ATTN: Inspections Staff
RE: Forest Lakes Filing 7 - Pond A

Project: **FOREST LAKES FILING 7**

Basin ID: **POND A - ASBUILT**

DETENTION BASIN OUTLET STRUCTURE DESIGN

DETENTION BASIN OUTLET STRUCTURE DESIGN

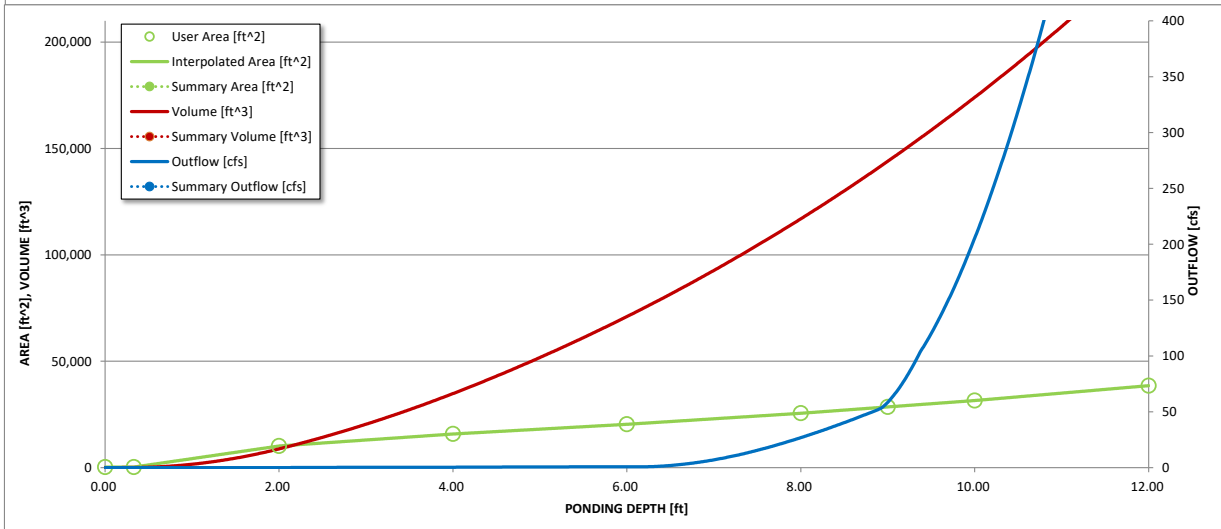
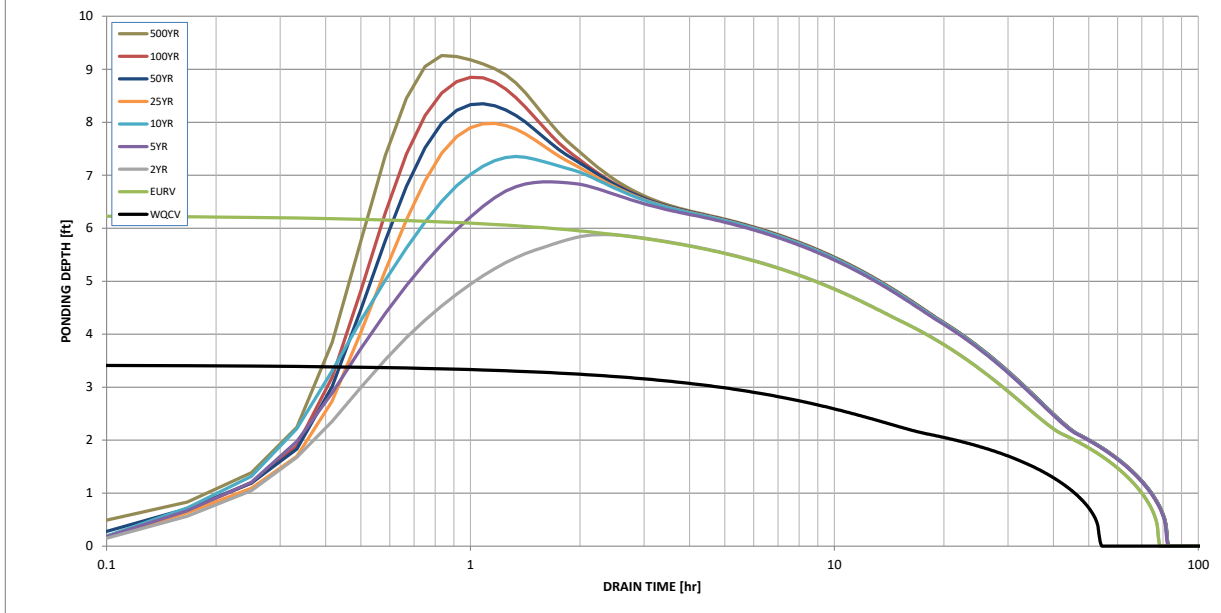
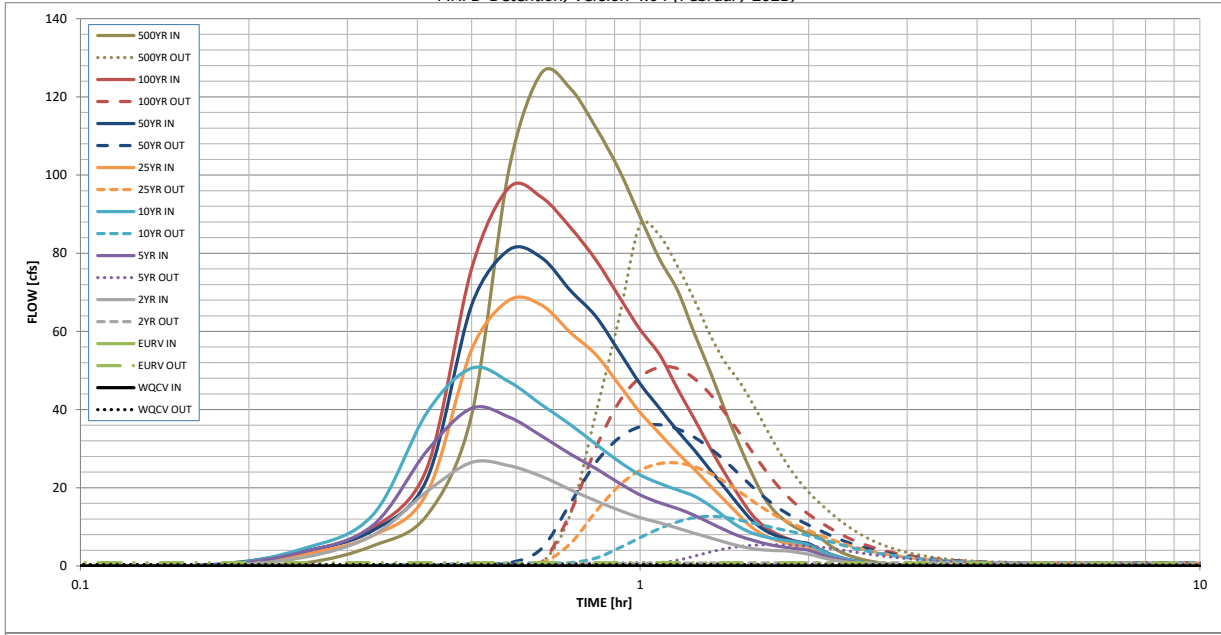
still doesnt match as-built CDs. See my comment on Sht 25 of CDs.
